PETITION FOR ZONING RE-CLASSIFICATION
SPECIAL EXCEPTION AND/OR VARIANCE

Bruce Spealman
R-66-345
NE/S Liberty Rd., 2.032.3' NW of the
c/l of Deer Park Rd.,
2nd Elec. Dist.

RE: Item No. 11 - Cycle II
October 1985 - April 1986
Petitioner - Bruce Spealman
Reclassification Petition

ZONING RECLASSIFICATION PETITIONS: CYCLE 11
Report to the County Board of Appeals
by the
Baltimore County Planning Board

PLAT TO ACCOMPANY PETITION
FOR
RECLASSIFICATION OF PROPERTY
AT
10114 LIBERTY ROAD
ELECTION DISTRICT 2 BALTIMORE CO., MD.
AUGUST 28, 1985
SCALE: 1"=50'
REVISED: Nov. 18, 1985

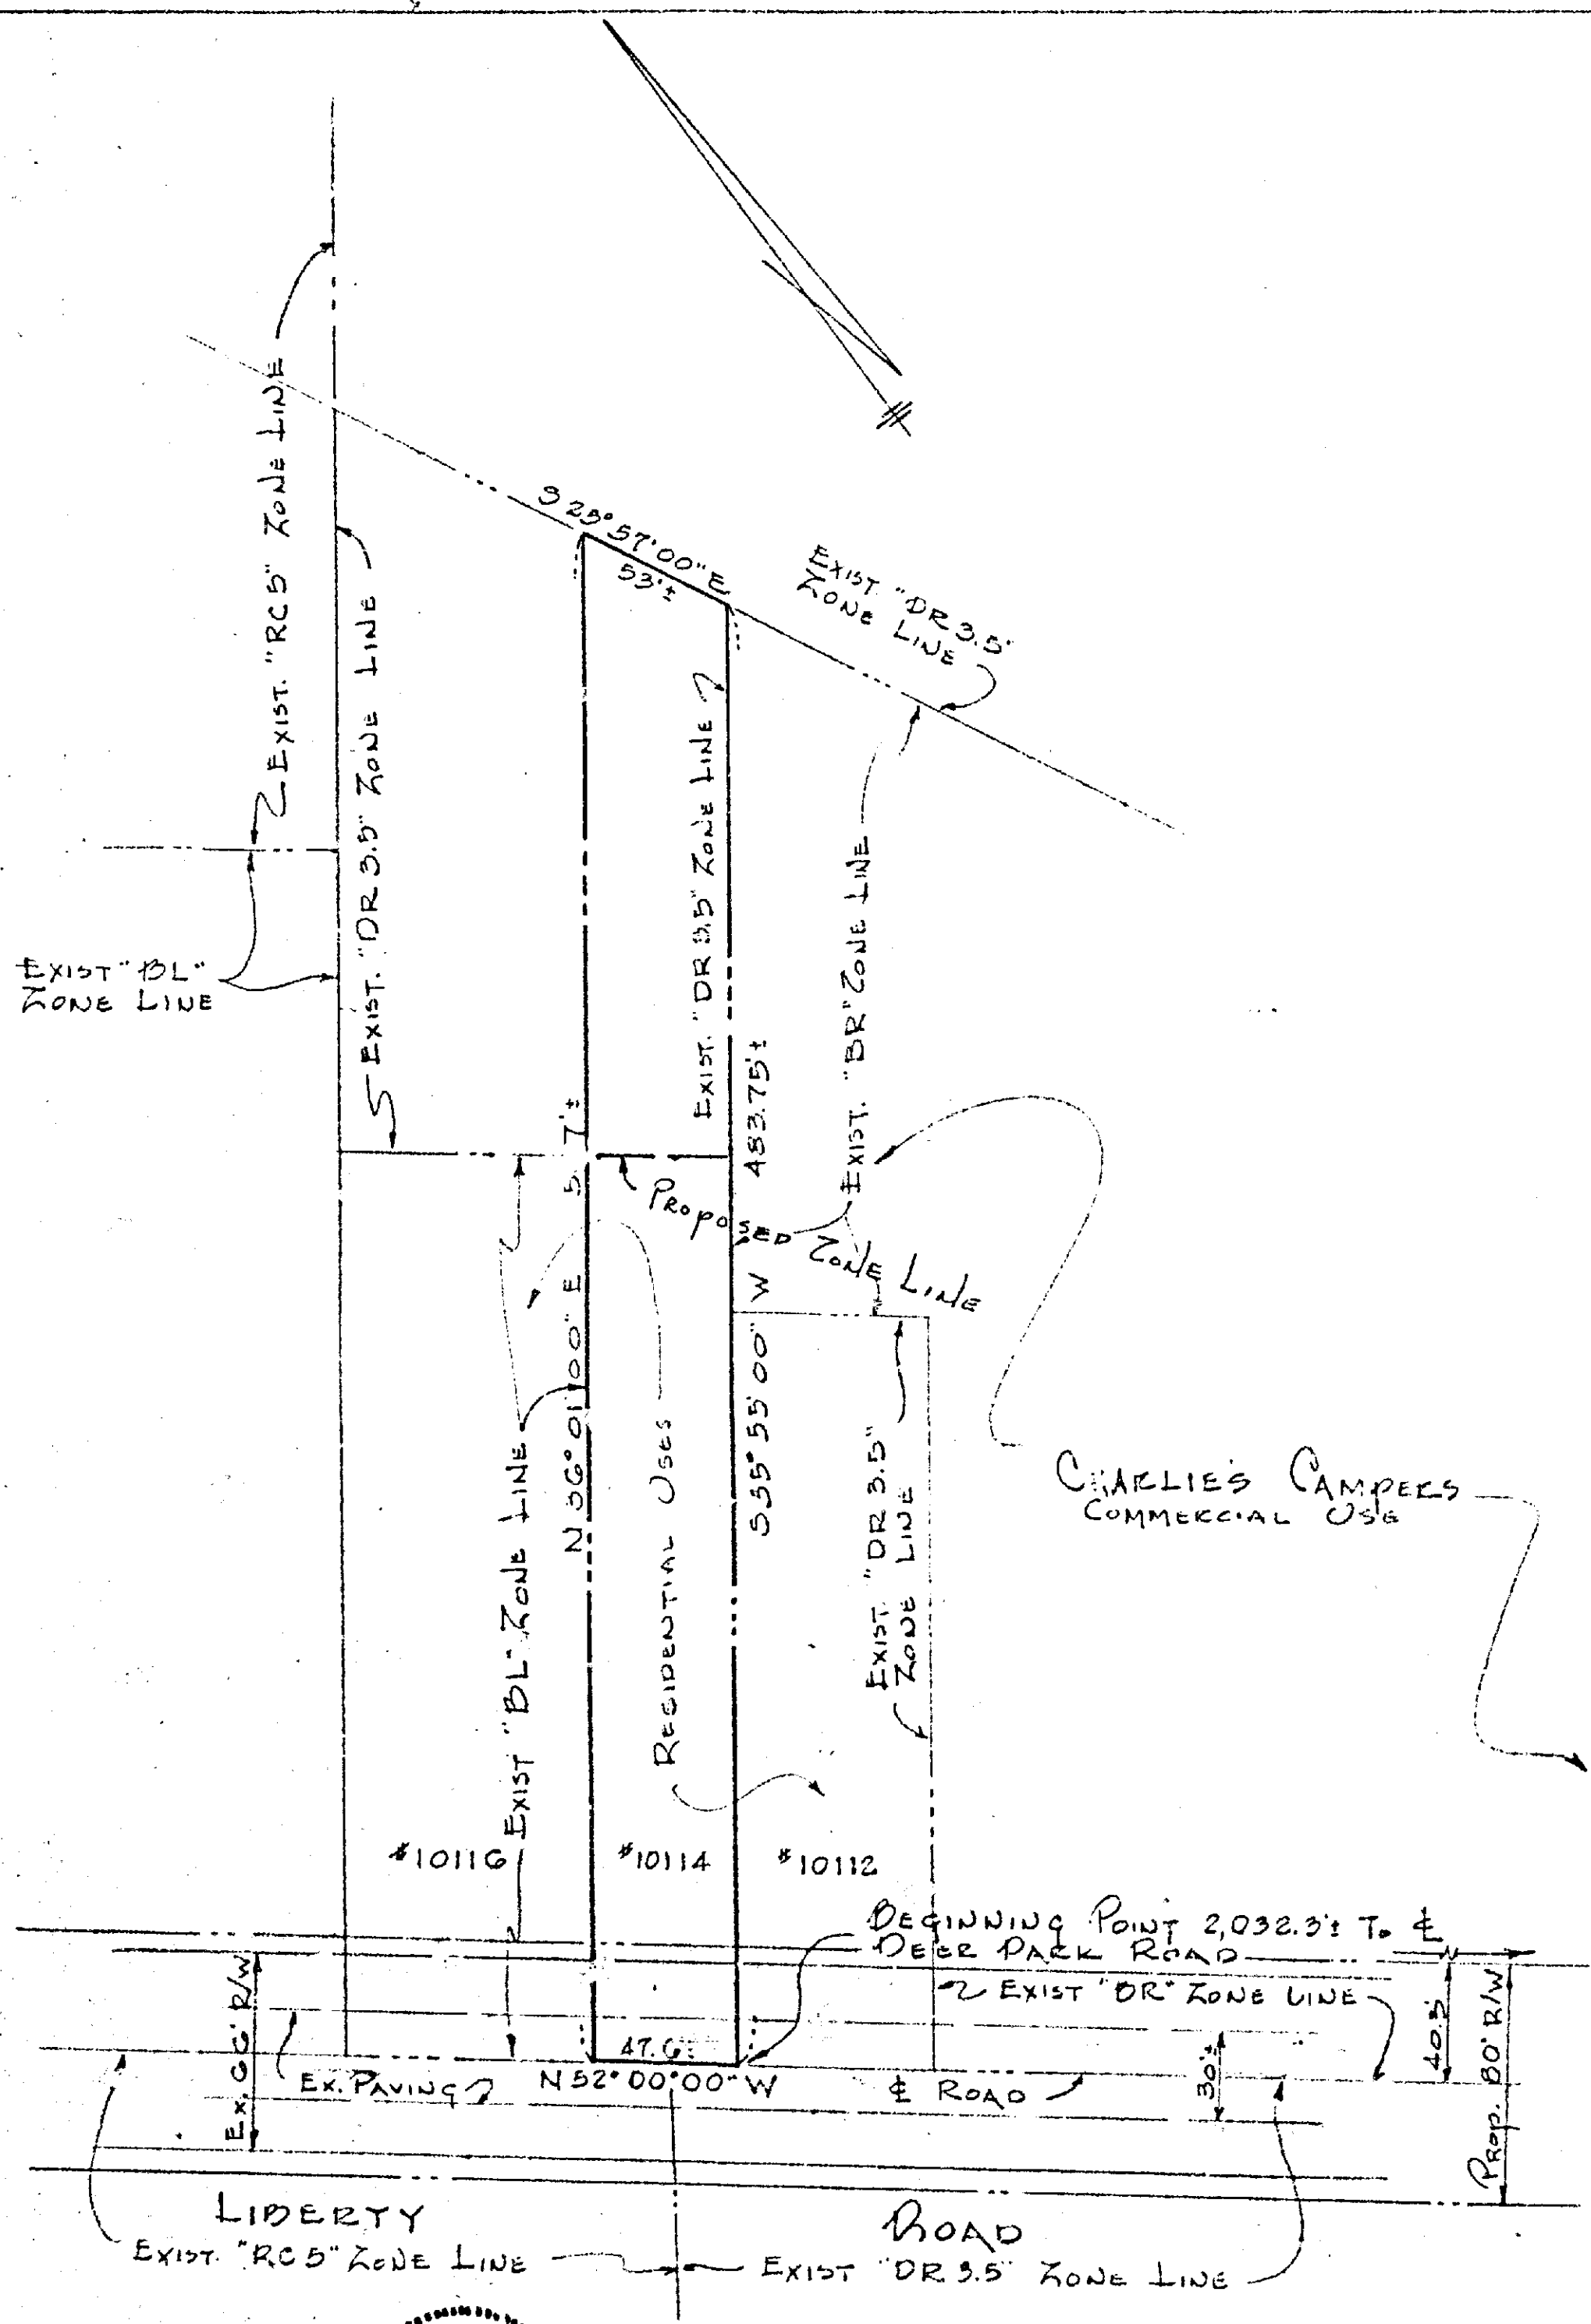
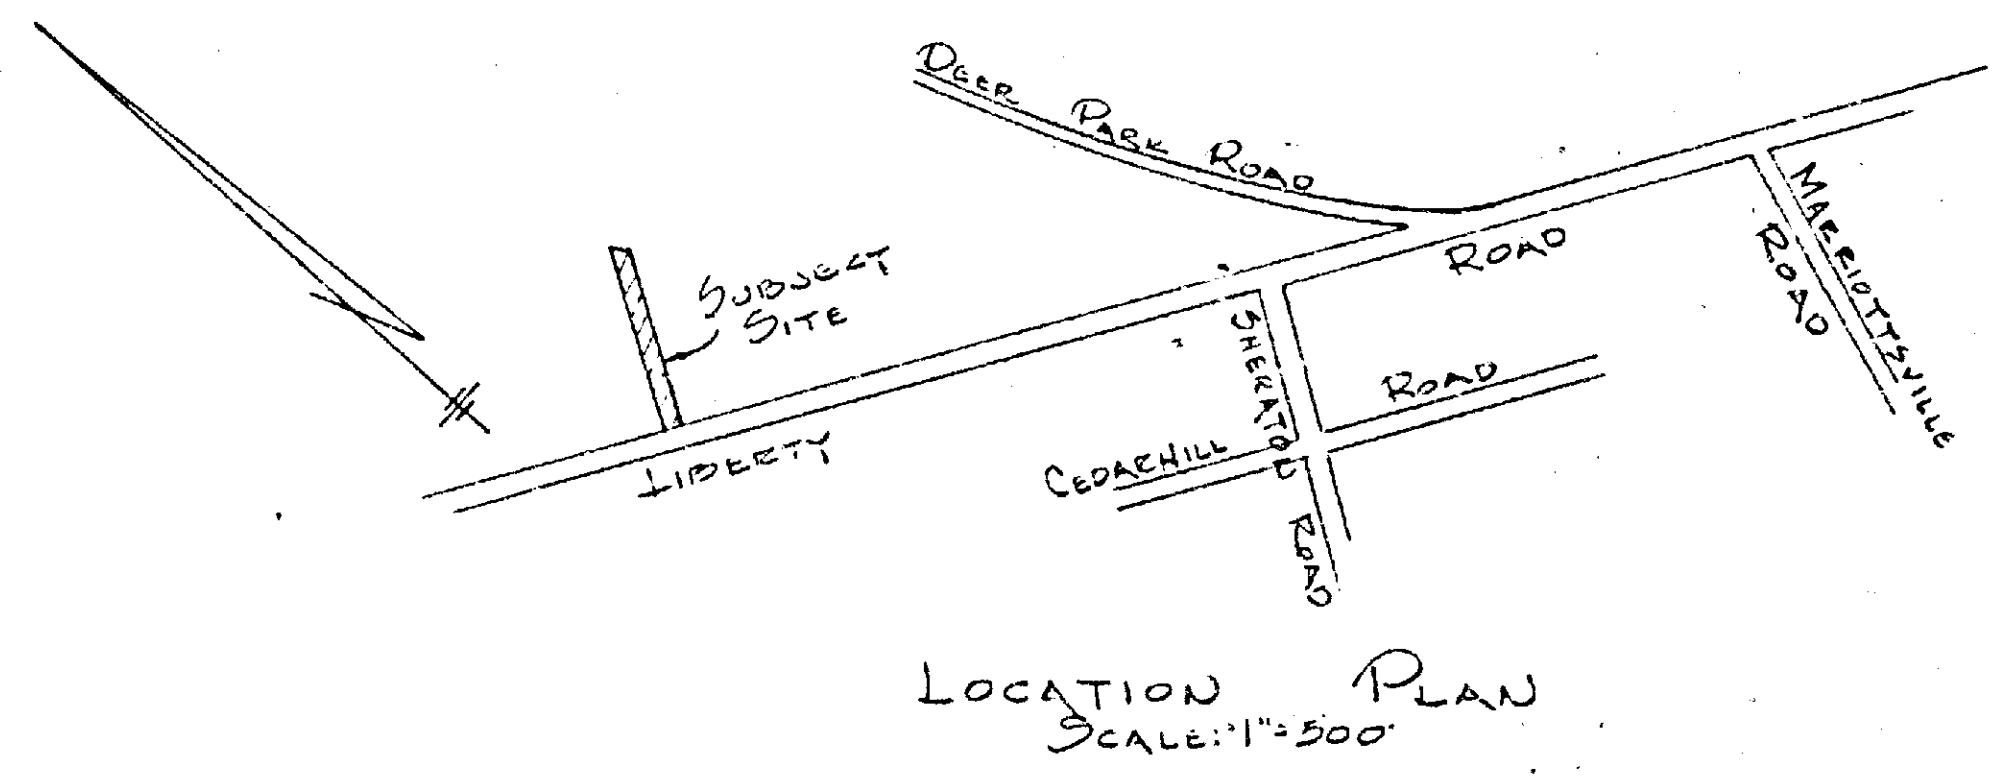
A proposed Right-of-Way of 80' must be shown, with a 40' b section centered on Liberty Road - Route 26.

A proposed Right-of-Way of 80' must be shown, with a 40' section centered on Liberty Road - Route 26.

NO	REVISION	DATE
1	ADDED Prop. 80' R/W For LIBERTY RO.	11/18/85
